**Pebble Limited Partnership
Request for Appeal of Permit Denial
United States Army Corps of Engineers Permit Application No. POA-2017-00271**

January 19, 2021

**Pebble Project - Compensatory Mitigation Plan
USACE Review Comments and PLP Responses**

Exhibit 2

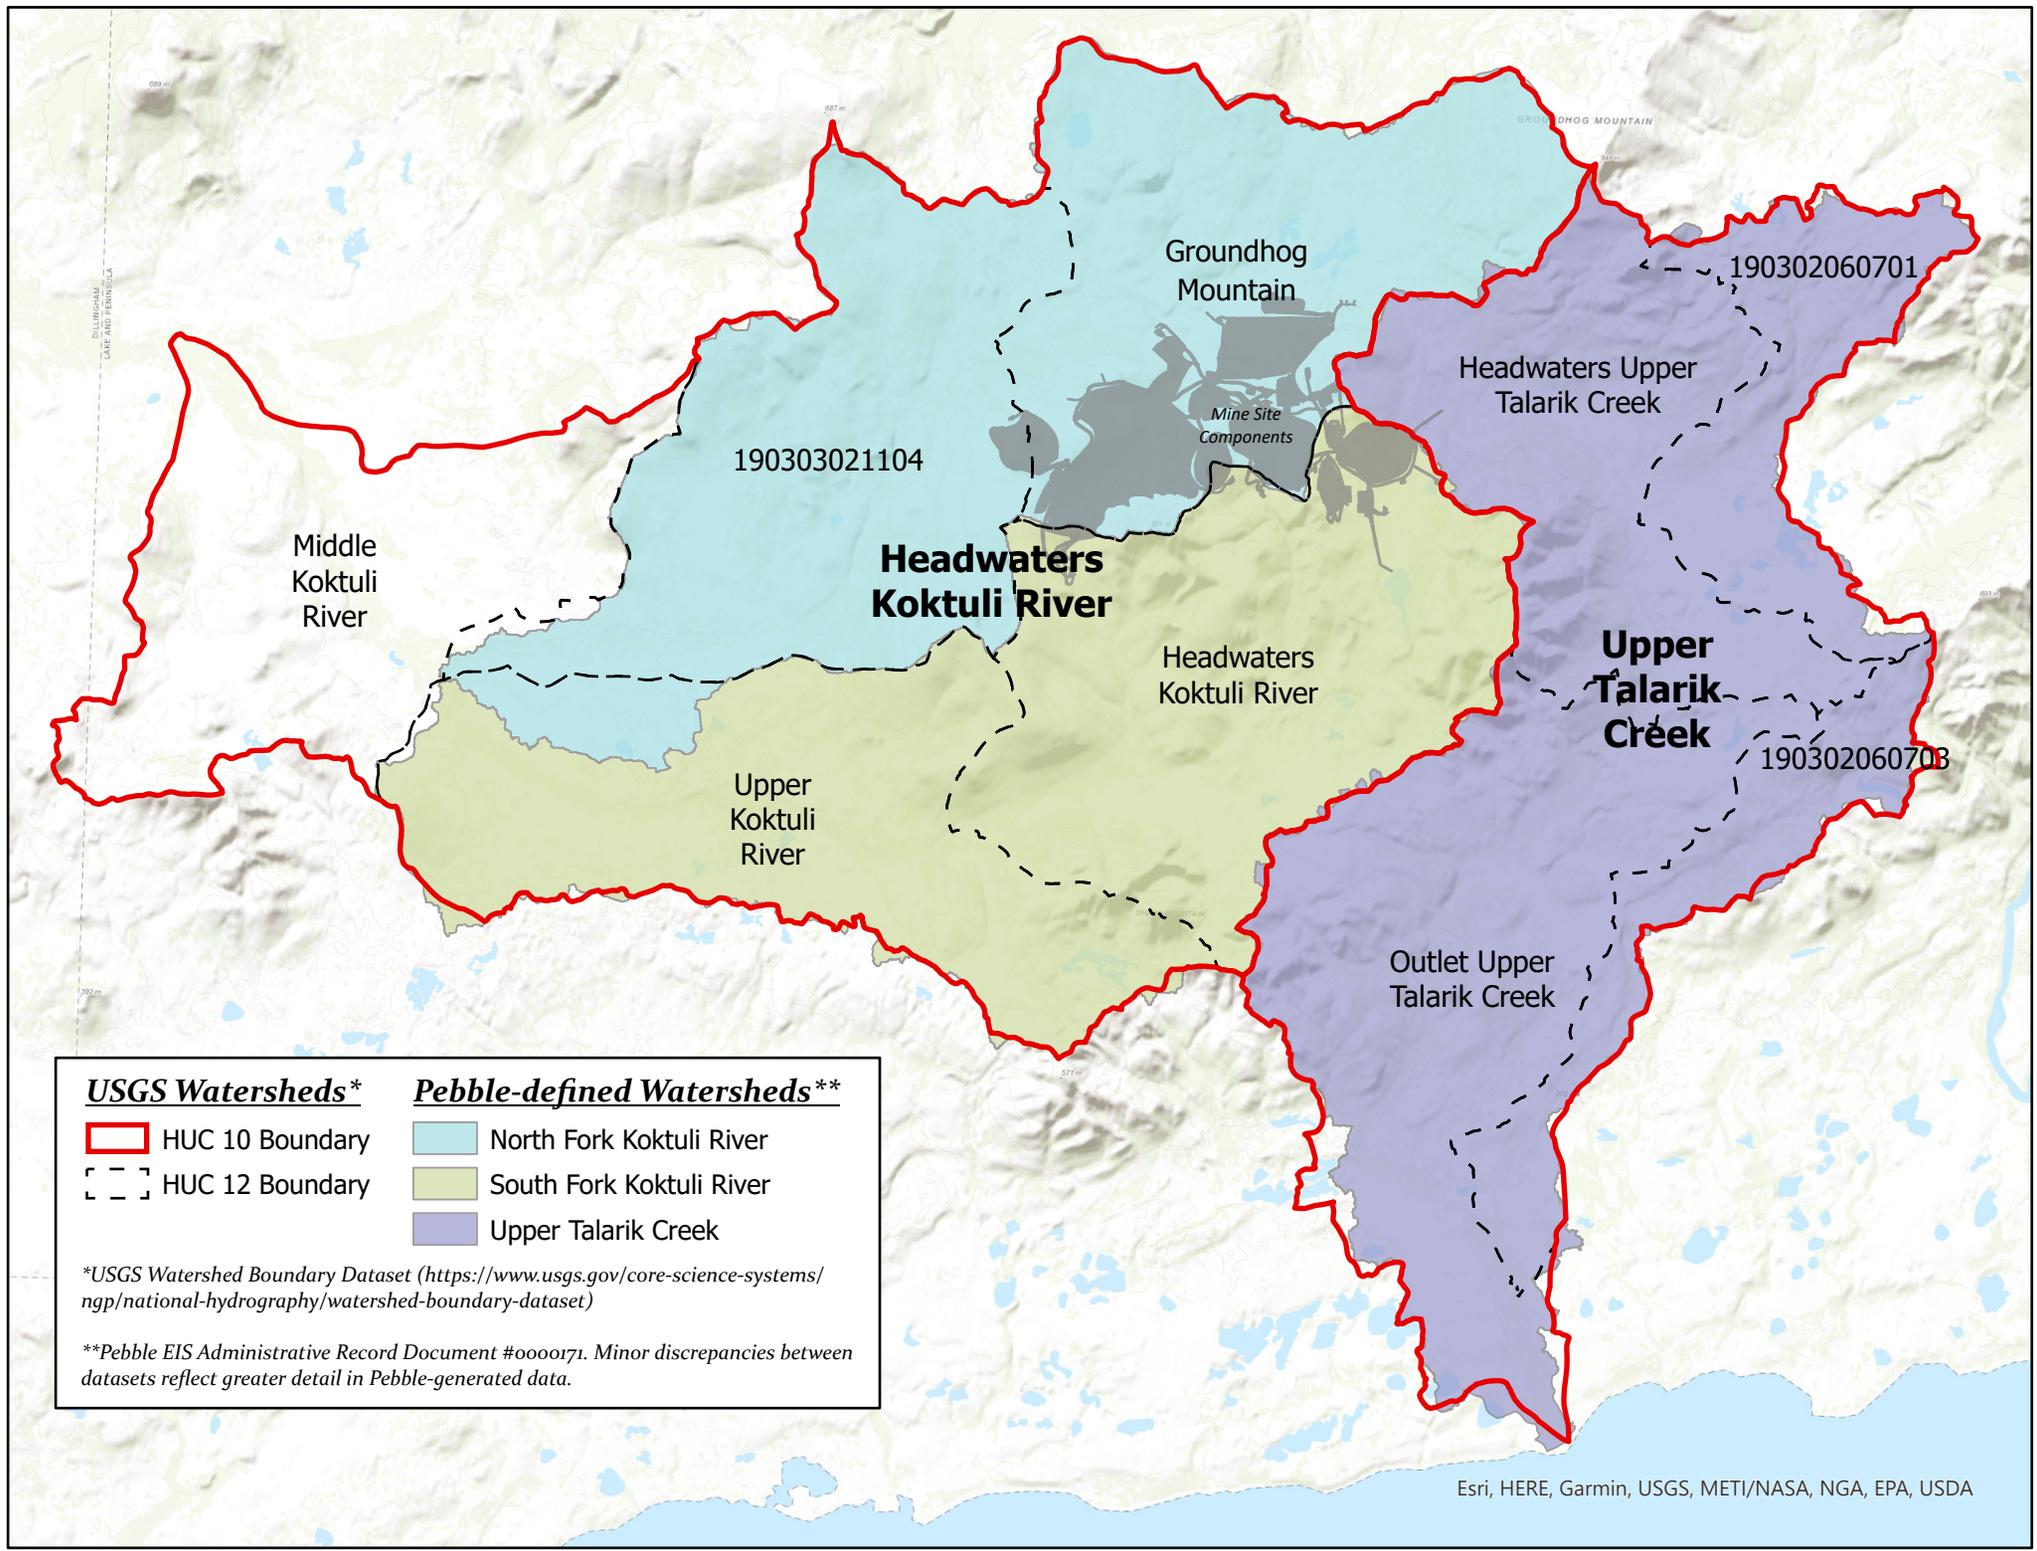
Watershed Scale. Certain environmental factors in Alaska suggest that larger watershed scales than are commonly used in the lower 48 states may be appropriate. These factors include, but are not limited to: (1) *large areas where wetlands remain relatively free from human alteration and opportunities for wetland restoration and enhancement are limited*; and (2) large wetland dominated areas where there is a lack of upland sites appropriate for establishing wetlands.¹²⁰
